UNITED STATES PATENT AND TRADEMARK OFFICE

10/735,030

Office Action Summary	Application No. 10/735,030	Applicant(s) SAADAT ET AL.	
	Examiner AMY T. LANG	Art Unit 3731

DETAILED ACTION

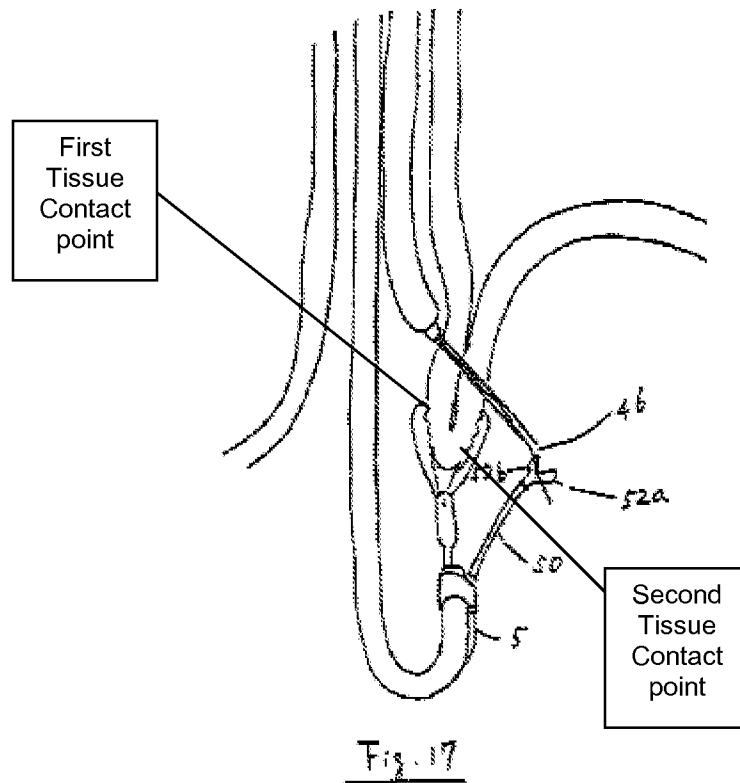
Jaffe discloses an overtube, guide tube (14), designed to facilitate insertion of an endoscope through a tortuous pathway ([0002]). The guide tube is slideably disposed over the catheter and comprises a flexible and rigid state (Figure 1; [0028]; [0037]; [0038]). As shown in Figure 3, tensioning elements (30) transition the overtube between the flexible and rigid states ([0041]). Therefore, tensioning elements (30) clearly overlap the instantly claimed mechanism. It is the examiner's position that the tensioning elements are configured to be manipulated from outside a patient's body. Since the overtube of Jaffe advantageously facilitates insertion of an endoscope through an internal passageway, it would have been obvious to one of ordinary skill at the time of the invention for Suzuki to utilize the overtube of Jaffe.

Additionally, Jaffe teaches the distal end of the guide tube can be controlled through a steering capability to provide an optimal pathway through the patient ([0044]). Tensioning elements (30) are also disclosed as steering the distal end of the overtube by causing it to "flex into different position" ([0044]) and therefore overlap the instantly claimed steering wires. Since Jaffe teaches multiple tensioning elements (30A, 30B, 30C, and 30D), it is the examiner's position that, for instance, tensioning elements 30A

and 30B overlap the instantly claimed steering wires and tensioning elements 30C and 30D overlap the instantly claimed mechanism to transition the overtube.
